PLAN COMMISSION

May 23, 2017
6:00 P.M.

Plan Commission Report

PROJECT: Plan Review – Jerry Cousin, All Star Honda (All Star Buick/GMC)

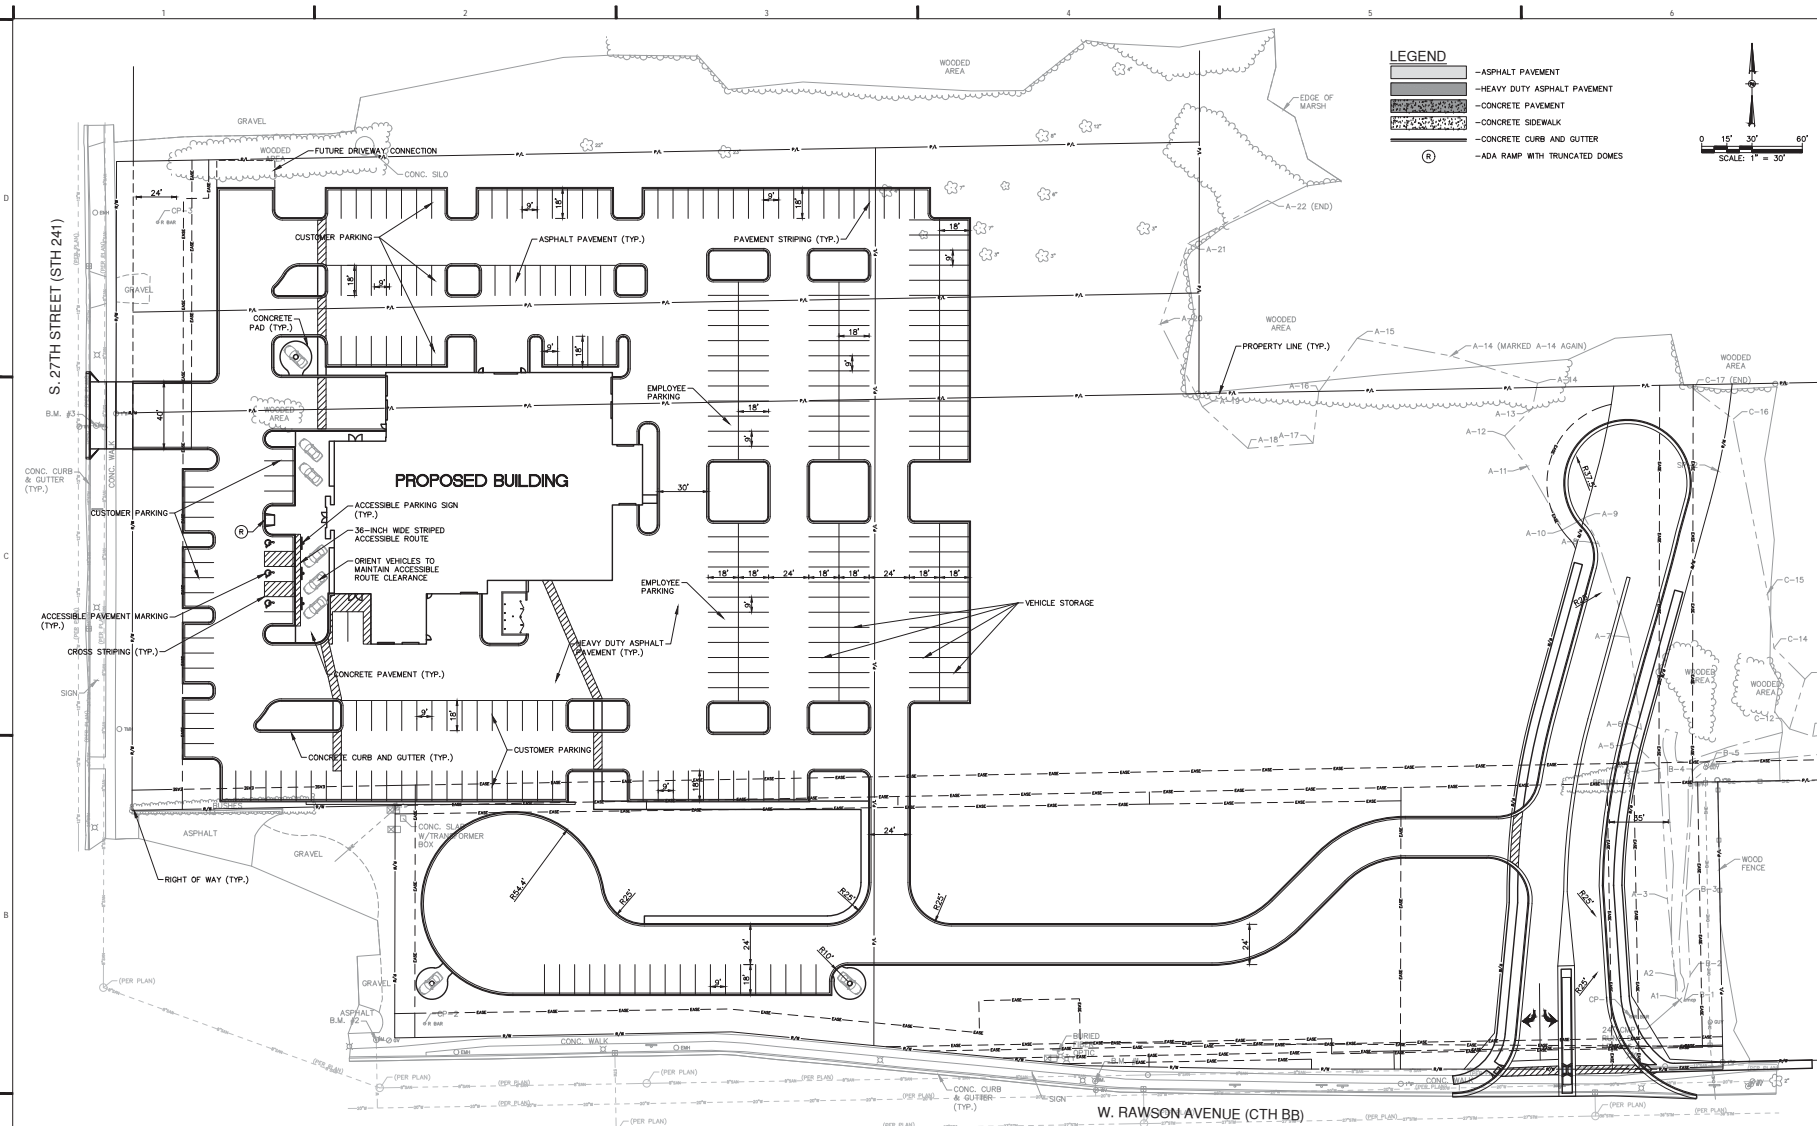
Comments received from the Water and Sewer Utility, and provided to the Applicant and their consultants, state that the sanitary lateral cannot discharge into a manhole – it must discharge directly into the sanitary sewer main. Two connections for fire are not allowed to the public main. One connection for fire and one for domestic service are required. These comments must be incorporated into the revised plans.

Comments were also received from the Engineering Department throughout the internal review of the plans. While the plans show a “frontage road” that ties into the proposed public road, Engineering would prefer to see the frontage road completely removed from Rawson Avenue. The Department also reiterates the requirement for WisDOT and Milwaukee County approvals for the access drives (the access permissions previously granted must be modified to allow for the proposed locations in the plans). Wetlands and the stormwater infrastructure locations are also missing on the site plan received May 18.

- Although public sidewalks are provided in the S. 27th Street and Rawson Avenue rights-of-way, there are no direct public connections to those sidewalks provided in the proposal. Further, there are no dedicated pedestrian paths separate but adjacent to the vehicle display area along Rawson Avenue. Staff contends that there are viable options to provide better vehicular and pedestrian-friendly connections throughout the site.

VERSION	JOB NO.
3042	01210
DRAWN BY	CHECKED BY
MY	KM
SHEET NO.	
A4-1

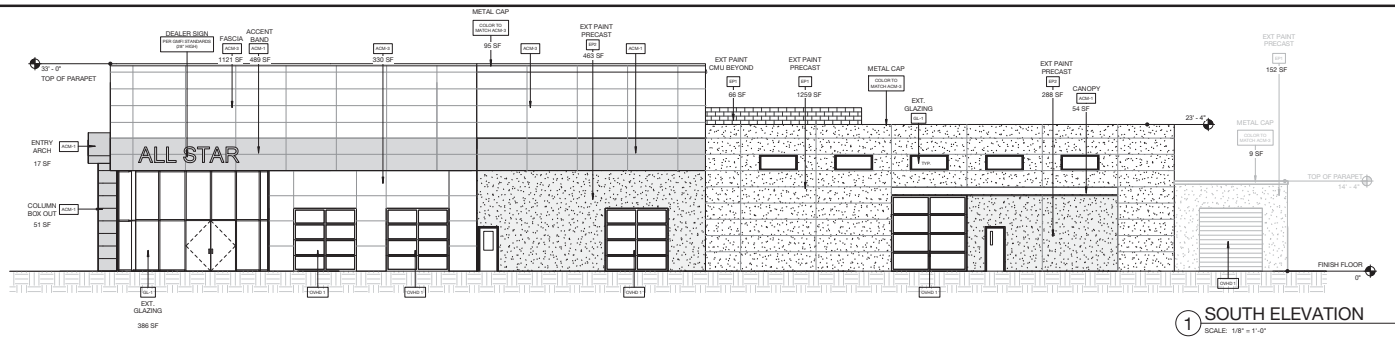
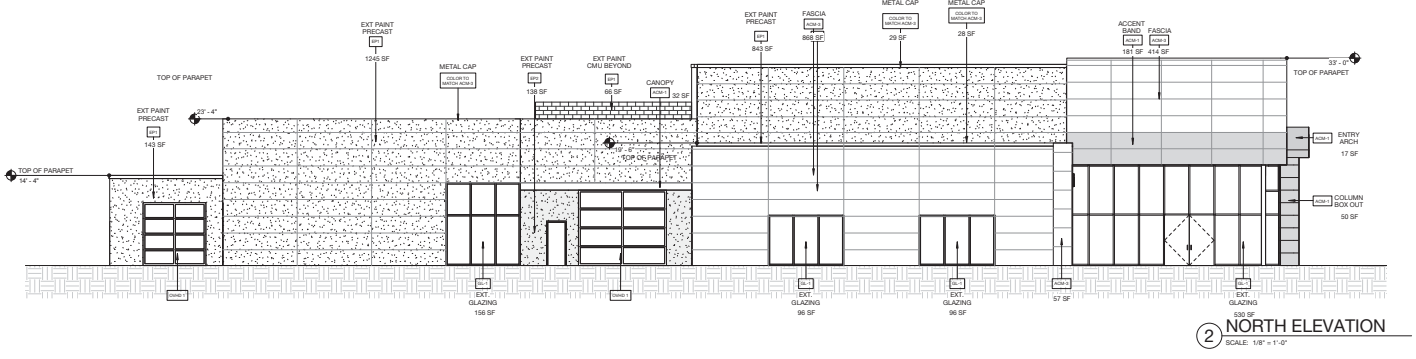
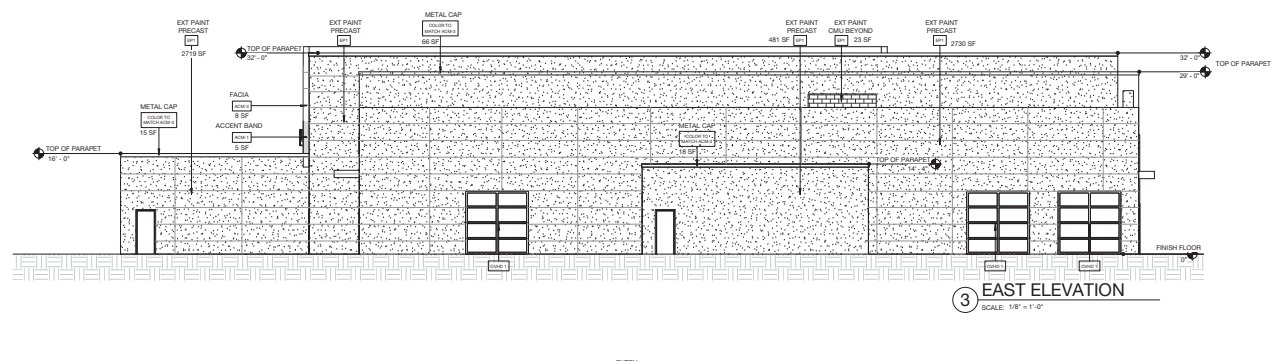
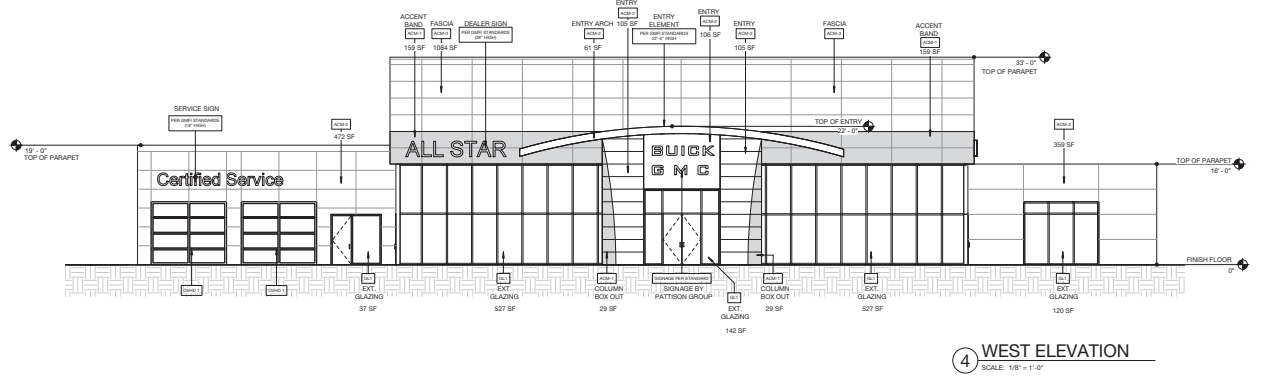
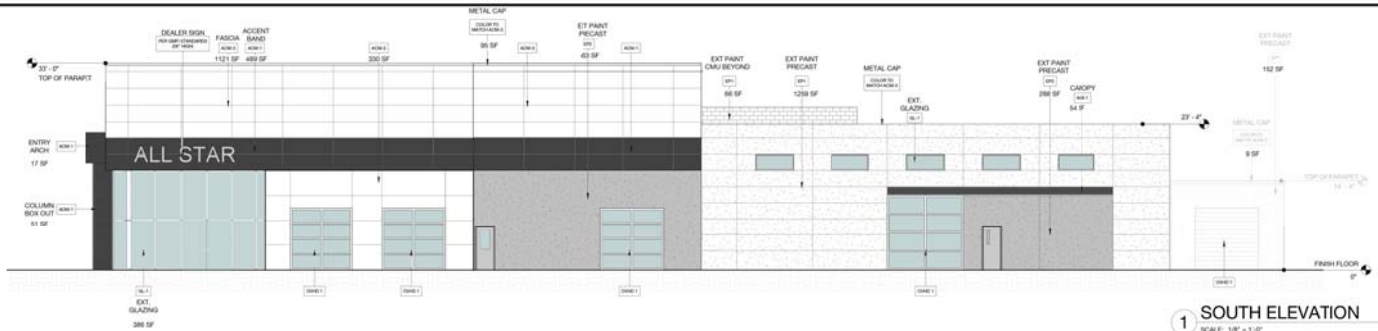
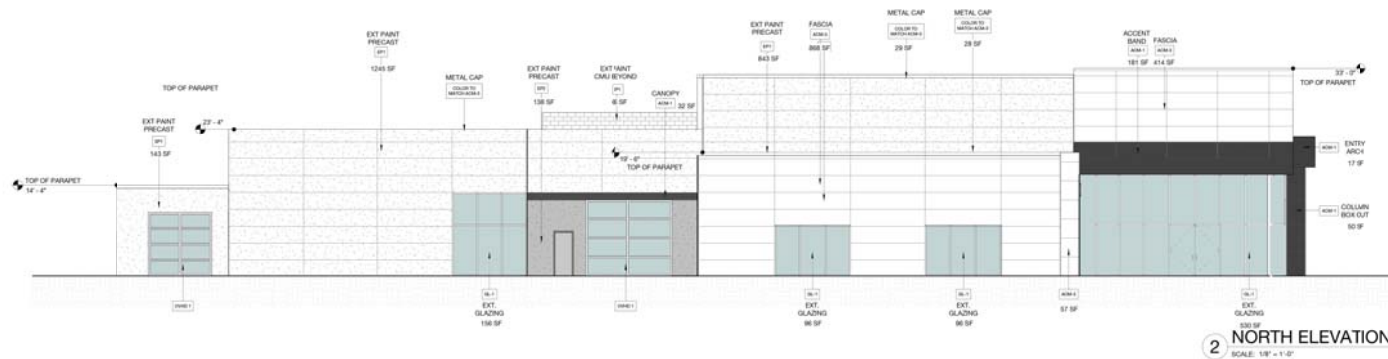
- With the parapet raised to hide the rooftop mechanicals, the appearance from 27th Street that the building is 2 stories is strengthened (although the building is functionally 1 ½ stories). While this Section requires buildings to be located “closer to the street,” it will be noted in the Regional Retail Overlay District Standards that the setback to a street right-of-way is a minimum of 50 feet. Previous versions of the plans did not identify “amenities that enhance pedestrian activity along the street” (27th Street, particularly).

- As mentioned in the review of the plans per the Standard Sections of Chapter 17 above, all but one of the overhead doors incorporate glass panes to mimic windows. This was a suggested compromise discussed in one of the many conversations between staff and the Applicant. Should the Plan Commission determine that the overhead doors with glass panes is not acceptable, they must be relocated so that they are compliant with the requirements of this and other Sections of Code. Plan Commissioners and the Applicant should understand that the use of glass overhead doors in areas not expressly in conformance with Code requirements must be approved as part of a request for modification of the standard.

- Metal panels are becoming more frequently proposed in plans received for review by the City. Although not specifically discussed during the building material training at the April 25 meeting, information was provided regarding their durability, aesthetics, etc. Staff has noted in reviews of other GMC dealerships throughout the country that use metal panels that some of the panels clearly show rusting and deterioration. Information regarding the quality and durability of the proposed panels must be provided to staff and the Plan Commission.

- As previously mentioned, the building does not use any of the materials required in this Section of Code, and the proposed materials do not meet the express requirements of other Sections of Code. Plan Commissioners will recall that a text amendment was recently passed by Council that would allow for a modification of standards as described below:

1 ENLARGED DUMPSTER PLAN
SCALE: 1/4" = 1'-0"

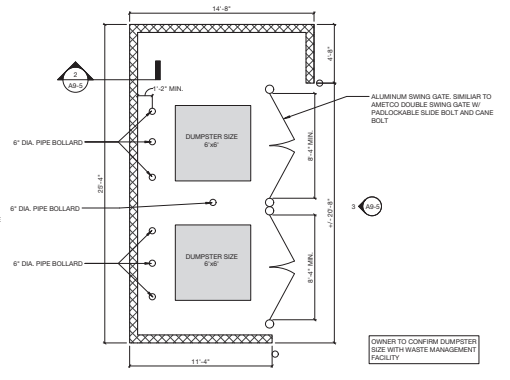
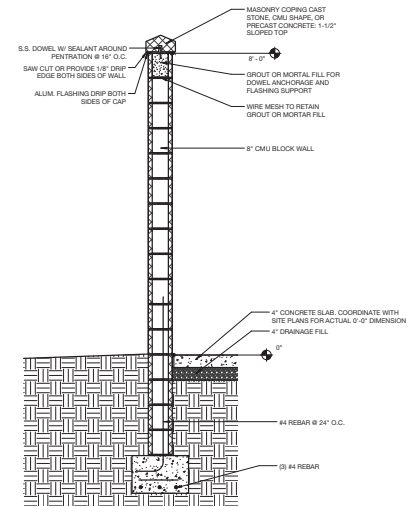
One 8-foot-tall CMU block dumpster enclosure with aluminum swing gates is provided on the south elevation. No color has been identified on the plans for the block or gates. Previous versions of the landscape plans showed vegetation surrounding the enclosure, which would be required in any revisions.
